**AMENDMENT AND RESPONSE**

Serial No.: 10/615,880

Title: COMPUTATIONALLY EFFICIENT DEMODULATION FOR DIFFERENTIAL PHASE SHIFT KEYING

**Amendment to the Drawings**

Figure 1  
 $\langle \hat{r}_{\text{prior}} | A_{t+1} \rangle$

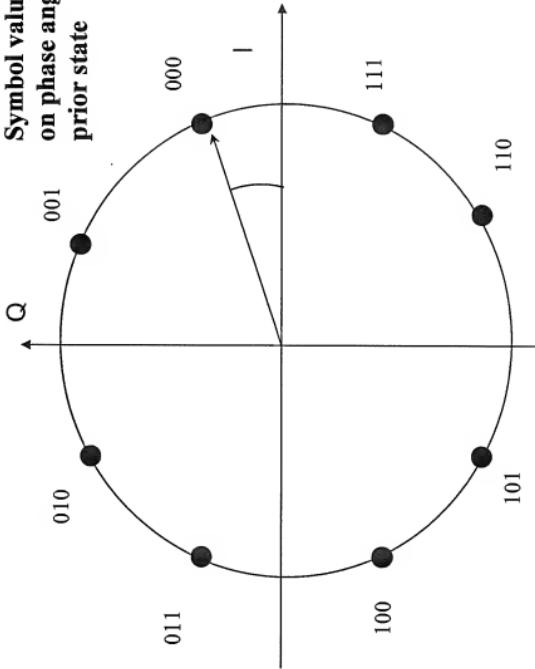
Fig. 1 – The legend “Prior Art” has been added.

Figure 2  
(PRIOR ART)

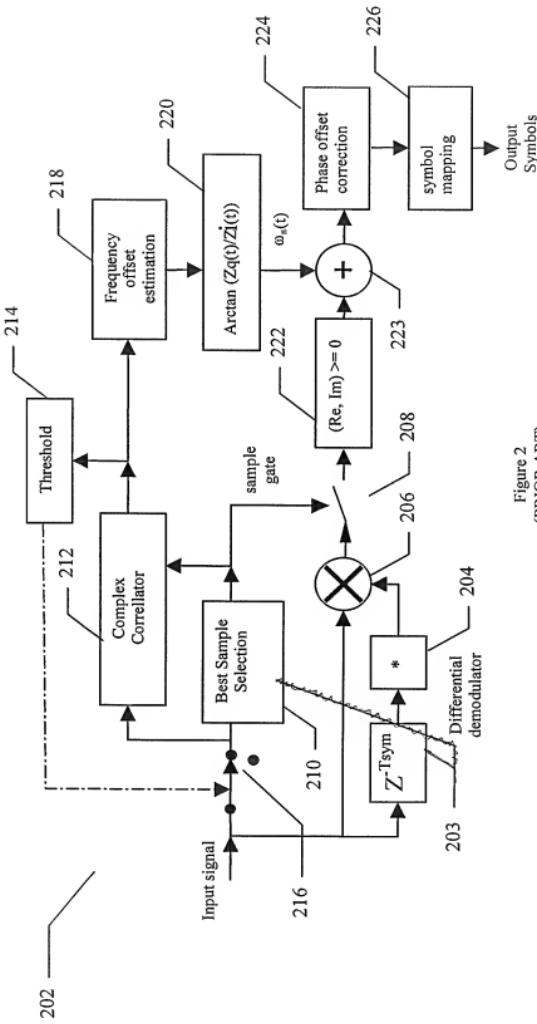
Fig. 2 – The lead line for element 203 has been correct.

Figure 3

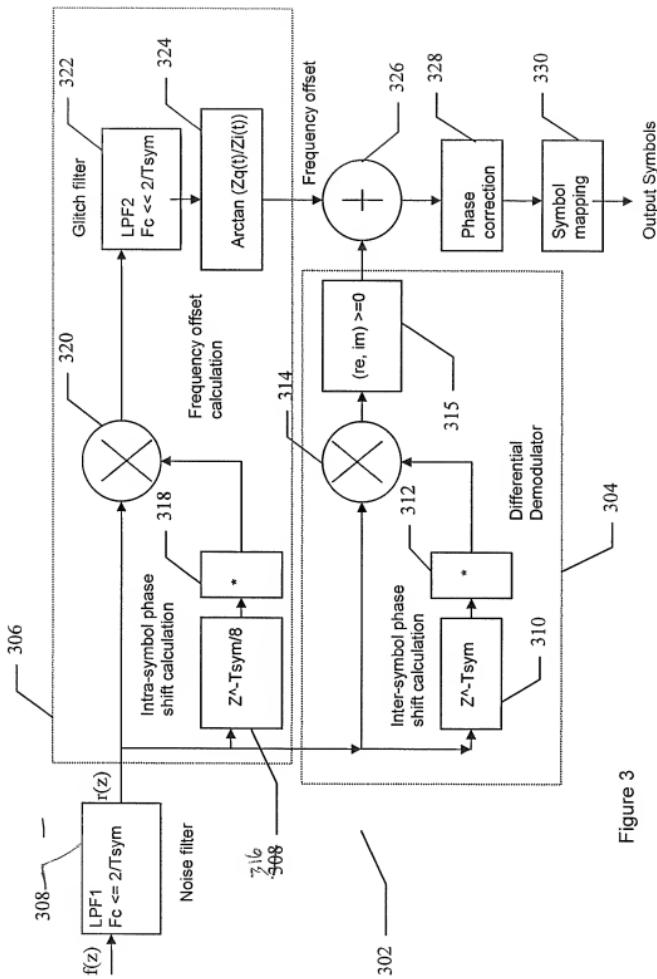
Fig. 3 – The reference numeral for delay circuit 316 in frequency offset calculator 306 has been corrected.
